## 5.6. MATERIAL CHANGE OF USE - MULTIPLE DWELLINGS & SHORT-TERM ACCOMMODATION - 69 - 73 MURPHY STREET PORT DOUGLAS

<b>REPORT AUTHOR</b>	Neil Beck, Team Leader Planning
<b>MANAGER</b>	Paul Hoye, Manager Environment and Planning
<b>DEPARTMENT</b>	Environment and Planning
<b>APPLICATION NO</b>	MCUC 2021_4490/1
<b>PROPOSAL</b>	Material Change of Use (Multiple Dwellings & Short-term Accommodation)
<b>APPLICANT</b>	Gurner TM Nominee Pty Ltd C/- Planning Plus PO Box 399 REDLYNCH QLD 4870
<b>LOCATION</b>	69 -73 Murphy Street PORT DOUGLAS
<b>PROPERTY</b>	LOT: 516 TYP: PTD PLN: <b>PARCEL</b> 2344 2094, LOT: 2 RP: 724386
<b>PLANNING SCHEME</b>	2018 Douglas Shire Council Planning Scheme Version 1.0
<b>ZONING</b>	Tourist Accommodation Zone
<b>LEVEL OF ASSESSMENT</b>	Code
<b>PROPERLY MADE DATE</b>	25 November 2021
<b>STATUTORY ASSESSMENT DEADLINE</b>	2 September 2022
<b>REFERRAL AGENCIES</b>	N/A

**Figure 1. South Elevation**

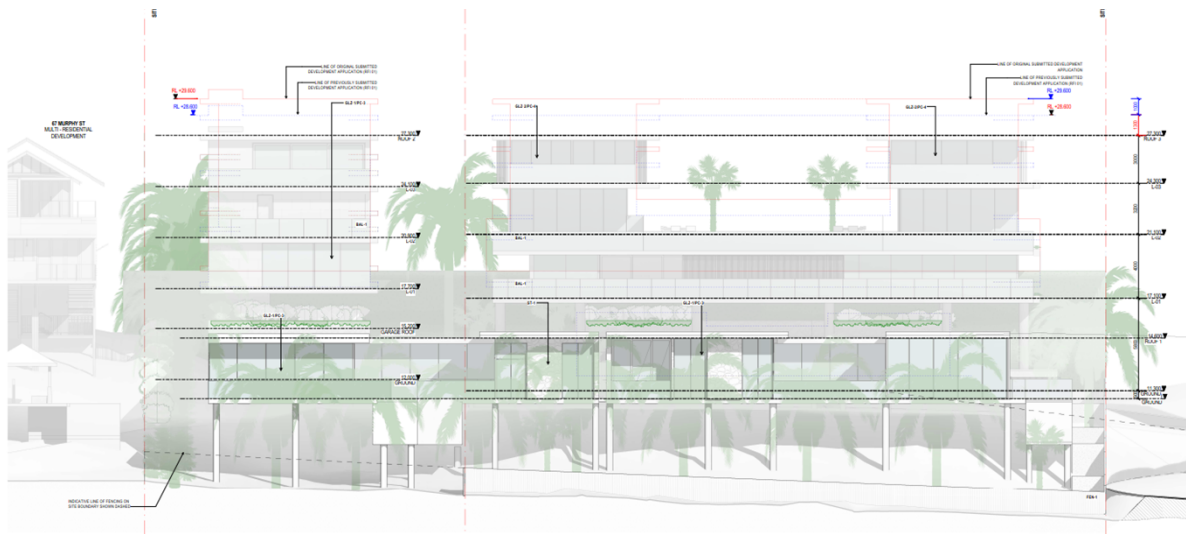
The south elevation (image below) is also “broken up” which provides building articulation and reduces the building bulk and massing when viewed from Macrossan Street, Jalun Park and foreshore areas.

**Figure 2. Revised design – reduction in building height & vehicle entry arriving at below existing ground levels.**

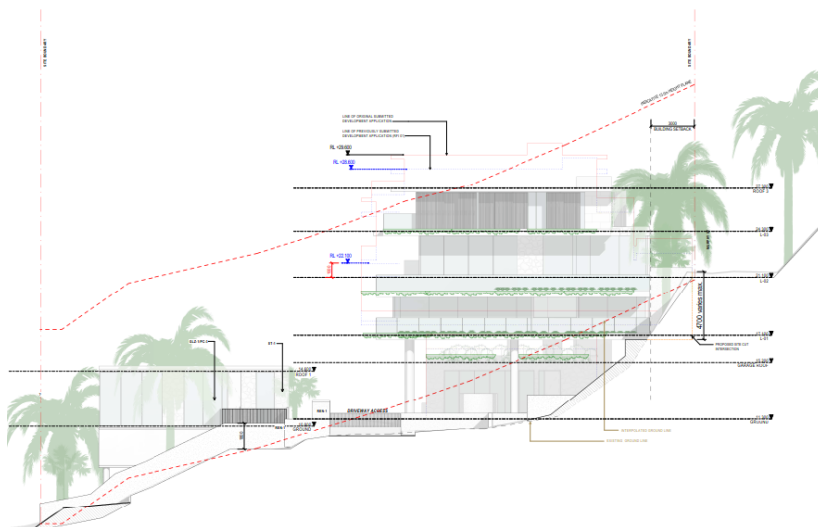
The building height has also been reduced by several metres as concerns were raised during the assessment process questioning the height of the building which resulted in undesirable outcomes external to the site with regard to the driveway design and associated works. In response to those items raised, the building has been lowered which also provides for less ramping and earthworks in the road reserve.

**Figure 3. Driveway Design**

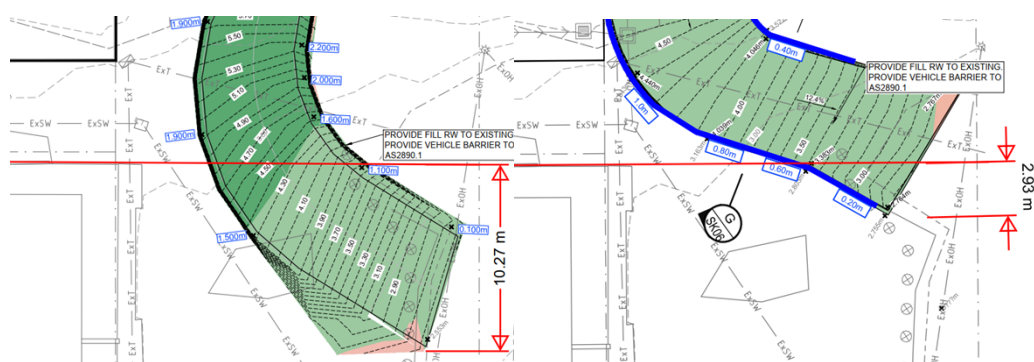
The images below show that the changes in the current revisions result in the driveway being moved approximately 7m northeast to reduce the encroachment across the frontage of the existing units.

The images also show that the significant filling and embankment impacts in front of the existing units are largely addressed. The red line in the images shows a projection from the outer wall of the existing units extending across the road frontage.

**Figure 4. Driveway Design**

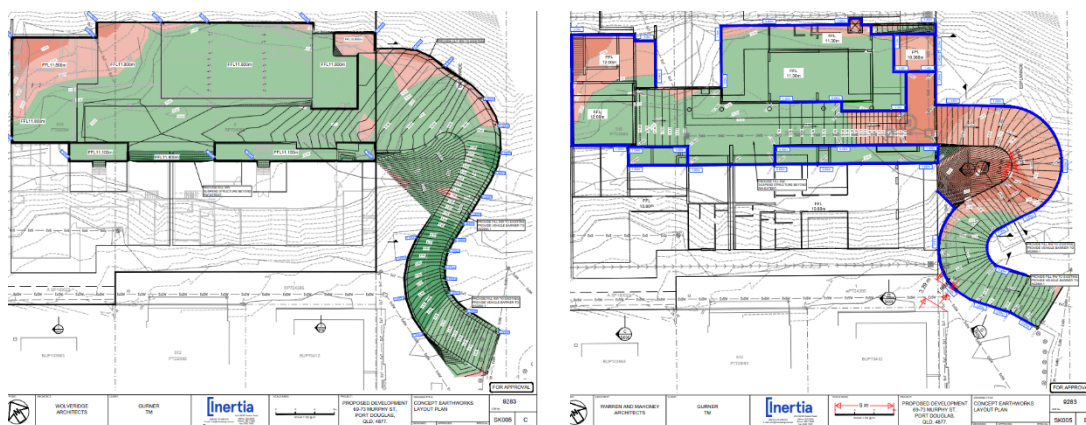
The driveway changes have resulted in much tighter turns on the driveway, (see images below).

The previous design also had a driveway width of 4m with the revised design being 6m in width however no discussion has been provided regarding the change or whether two-way traffic flow is proposed. Having regard to the turn templates provided, these confirm that the driveway can only accommodate one vehicle and one way operation of the driveway. The templates show that within the curved section, two vehicles cannot pass.

The finished surface contours provided on Inertia Engineer's drawing SK007 indicate that the longitudinal grade on the inside of the sharp curves is 25%. This is not consistent with the labelling on the architects plans that claim a maximum grade of "1 in 5.6 internal curve", (17.9%). This may be reflective of the travelled path, which raises questions on why the driveway design uses 6m width that cannot be driven on. AS2890.1 – Off Street Parking Code advises that the minimum inside radius for curved roadways and ramps is 4m. The current driveway does not appear to achieve the minimum set out in the Australian Standard. Vehicle barriers will also need to be provided in certain locations.

A condition of the approval requires further detail to be provided regarding operating procedures regarding the control of a one-way entry and exit. Further design modifications maybe necessary.

**Figure 5. Inertia Engineering Stormwater swale Drain – blue arrows**

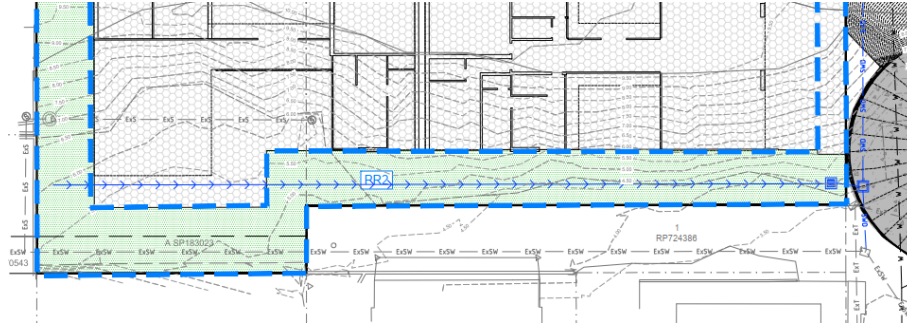
The elevations shown on drawing DA 20.004 and DA 20.002 (and sections 1 and 2 on DA30.001) do not reflect the representations on the Inertia Stormwater Plans as they do not show how stormwater run-off will be controlled within the lower portion of the site.

**Figure 6. Section 2 from Architects Drawings**

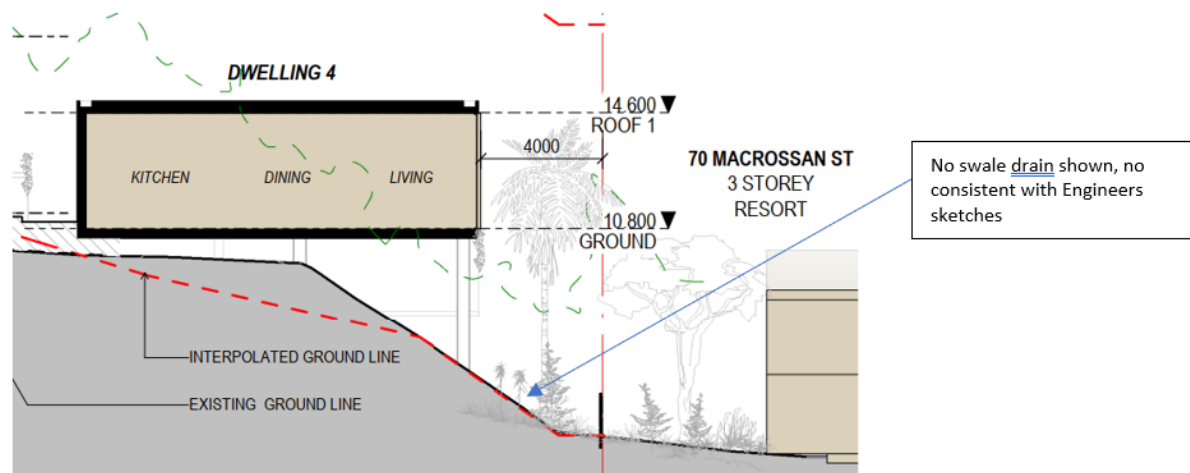
The Architect's sections do not show the stormwater drain along the southern boundary (as proposed by the Engineer) and therefore do not appear to make provision for the runoff to be contained within the site and conveyed to a lawful point of discharge.

**Figure 7. Landscape Plan**

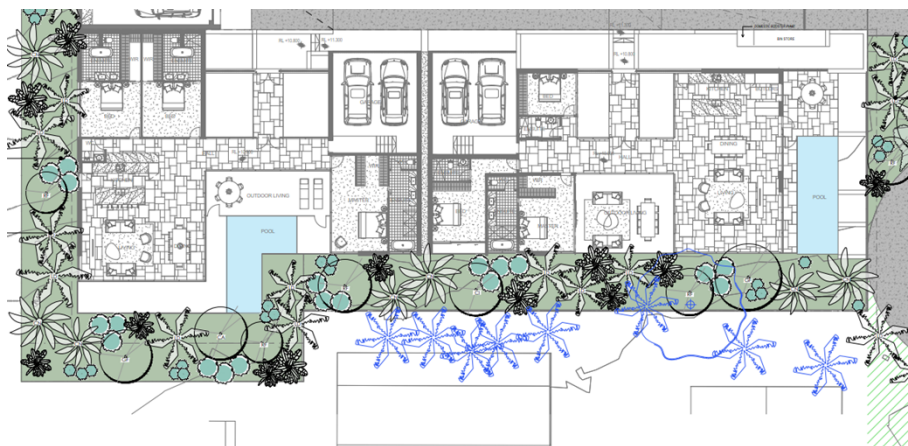
The screening density proposed appears to only be achievable with unrestricted use of the lower offset corridor, whereas stormwater conveyance requires the certainty of a defined (clear) flow path.

The two proposals of stormwater conveyance and dense screening plantings are mutually exclusive of each other.

The preferred approach to achieve both a superior stormwater outcome and the desired planting/screening outcome for the development is to upgrade the stormwater along the north-western and south-western boundaries and through to the esplanade outlet.

**Figure 8. Water main proposed to terminate on other side of the driveway**

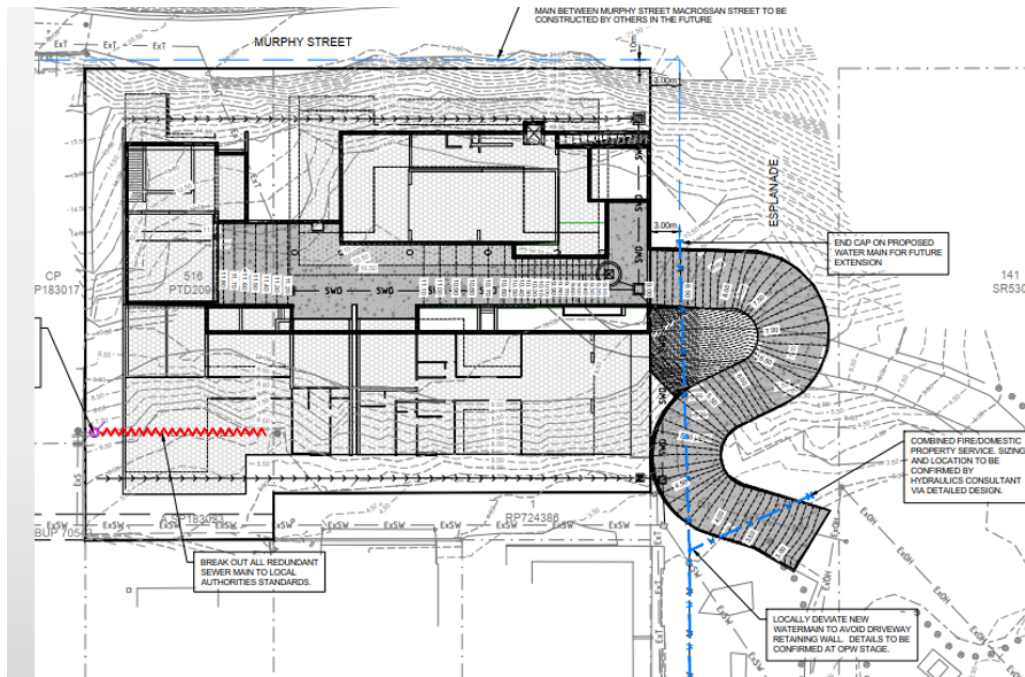
The extent of water main shown on the supporting engineering plans is not supported.

The proposed works to take place in the road reserve and the existing steep bank adjacent Murphy Street will significantly limit future construction options and access to the upper section of the Esplanade.

A condition of approval requires this section of the watermain be completed prior to the construction of the driveway with its retaining walls and cuttings.

**DA010.01**

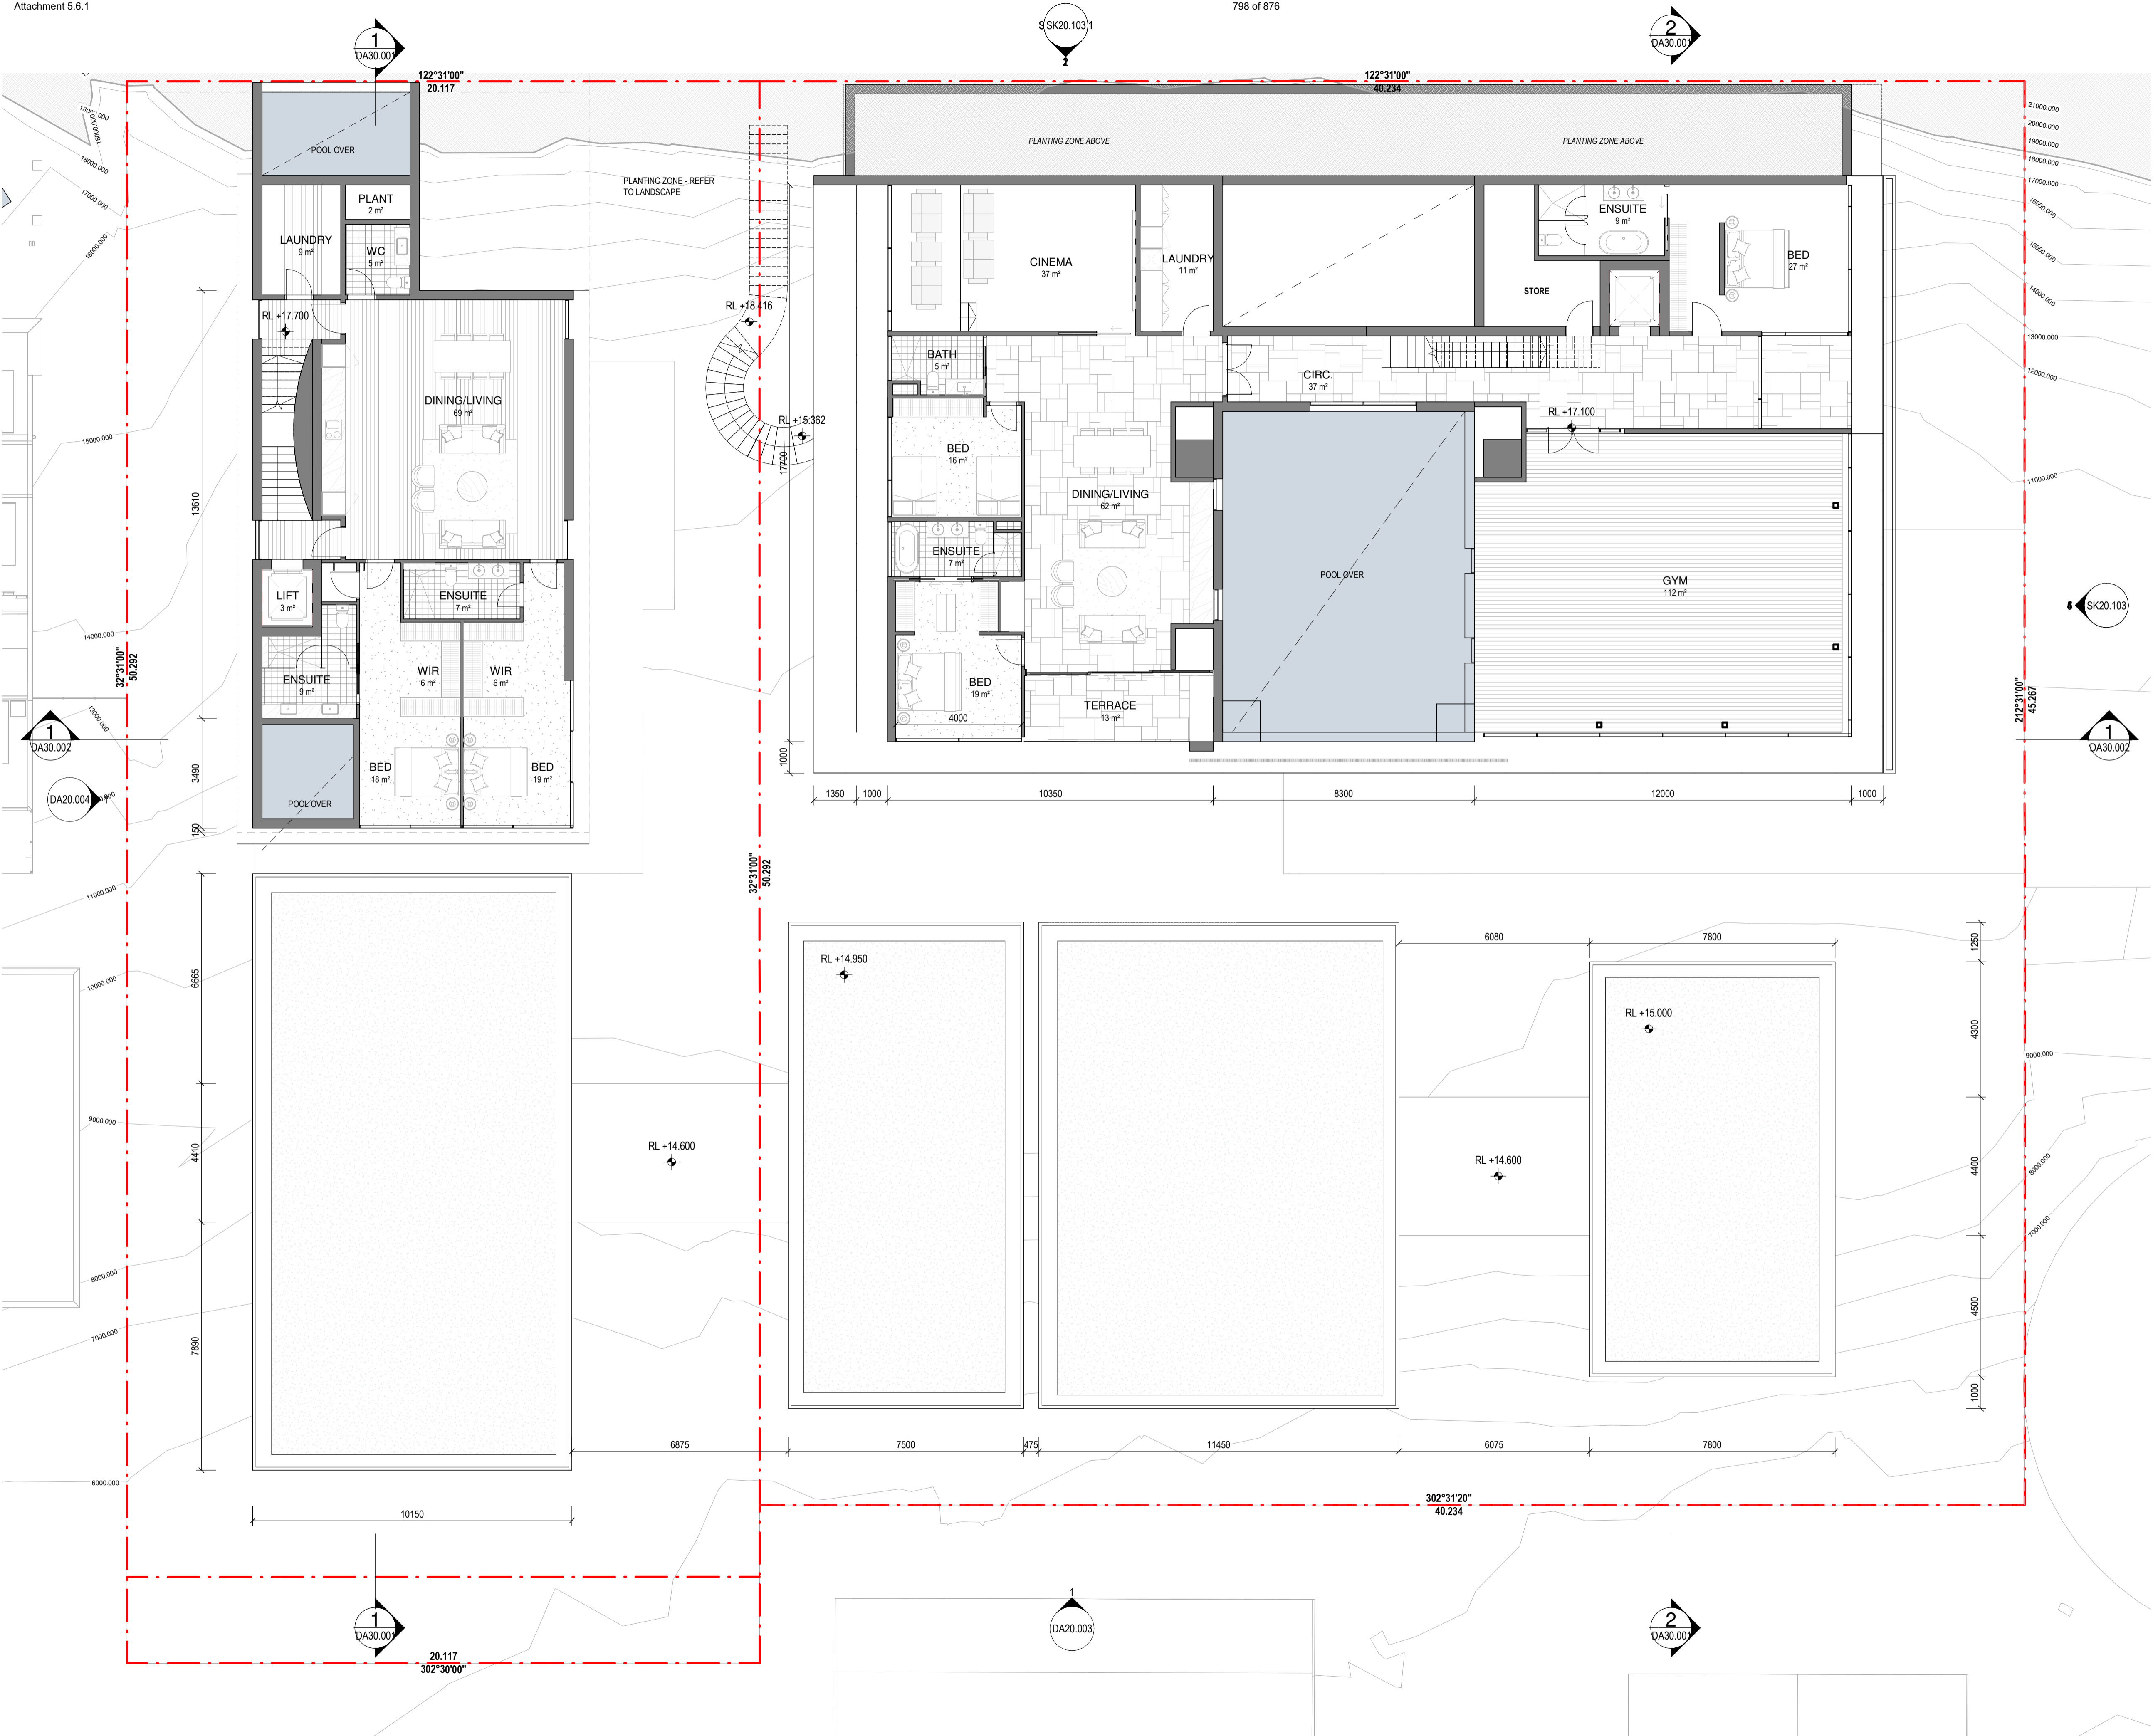
Ramp and gate width of DA010.01 scales at approximately 4.9m. Scaling on various plans indicates driveway width on ramp is limited to approx. 4.9m. The Applicant will need to confirm if the driveway is intended to allow for 2-way vehicle traffic. This element will need to be further explored as part of the vehicle entry and exit considerations for the external driveway.
